Access Compliance Report
Public Rights-of-Way
(Curb Ramps)

Intersection ID: N/A | **Main Street:** PROVIDENCE_RD | **Cross Street:** BERKELEY_GREENE_DR | **Location:** W

ADA ID: F98AE74A588B | **Ramp Type:** PerpDiag | **Initial Pass/Fail:** Fail | **Overall Compliance:** No | **Severity Score:** 13.75

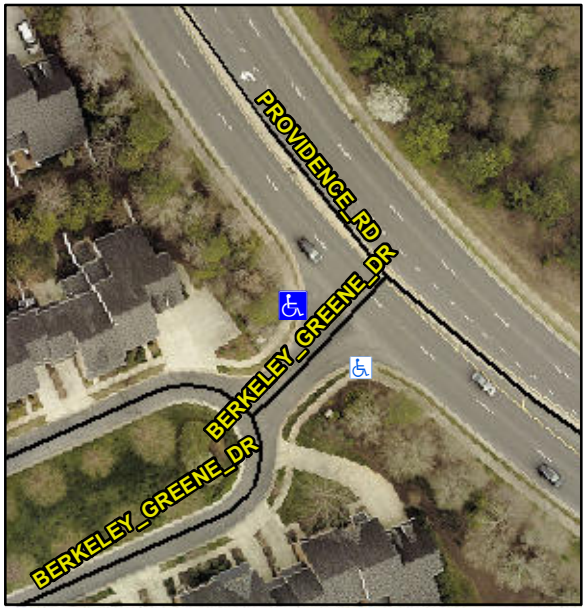
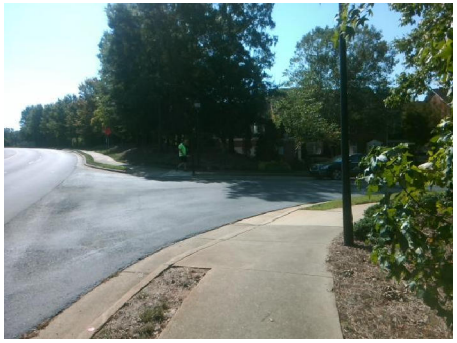
R304.2.2, R304.5.3

Compliance	Description	Data	Compliance	Description	Data
N/A	Ramp Length (in)	71.0	No	Ramp Slope (%)	8.7
Yes	Ramp Width (in)	49.0	No	Ramp XSlope (%)	3.9
N/A	Flare Type LT	N/A	N/A	Flare Type RT	N/A
N/A	Flare Slope LT (%)	N/A	N/A	Flare Slope RT (%)	N/A
N/A	Flare Traversable LT?	N/A	N/A	Flare Traversable RT?	N/A
N/A	Landing Length (in)	N/A	N/A	DWS Provided?	N/A
N/A	Landing Width (in)	N/A	N/A	DWS Contrast?	N/A
N/A	Landing Slope (%)	N/A	N/A	DWS Length (in)	N/A
N/A	Landing X Slope (%)	N/A	N/A	DWS Full Width?	N/A
N/A	Landing Curb? (Y/N)	N/A	N/A	DWS Offset (in)	N/A
N/A	Shared Landing?	N/A			
N/A	Gutter Ponding?	N/A	N/A	Gutter Slope (%)	N/A
N/A	Gutter Lip Ht (in)	N/A	N/A	Gutter X Slope (%)	N/A
N/A	Painted X Walk1?	No	N/A	Painted X Walk2?	No
	X Walk 1 Direction	To SE		X Walk 2 Direction	To NE
N/A	X Walk 1 Width (in)	N/A	N/A	X Walk 2 Width (in)	N/A
	X Walk 1 Slope (%)	5.2		X Walk 2 Slope (%)	0.9

X Walk 1 X Slope (%)	2.0		X Walk 2 X Slope (%)	4.0
N/A	Ramp inside XWalk1?	N/A	N/A	Ramp inside XWalk2?	N/A
	Road Slope (%)	0.7	N/A	Clear Space?	N/A
	Road X Slope (%)	3.8	N/A	Clear Space to XWalk (in)	N/A
N/A	Any Obstructions?	N/A	N/A	Storm Grate/Utility Hazard?	N/A
	Obstruction Type			Storm Grate/Utility Type	
		N/A			N/A
			Yes	Surface Condition? (G/P)	Good

Remove & Replace Curb Ramp With Two New Directional Ramps or Equivalent.
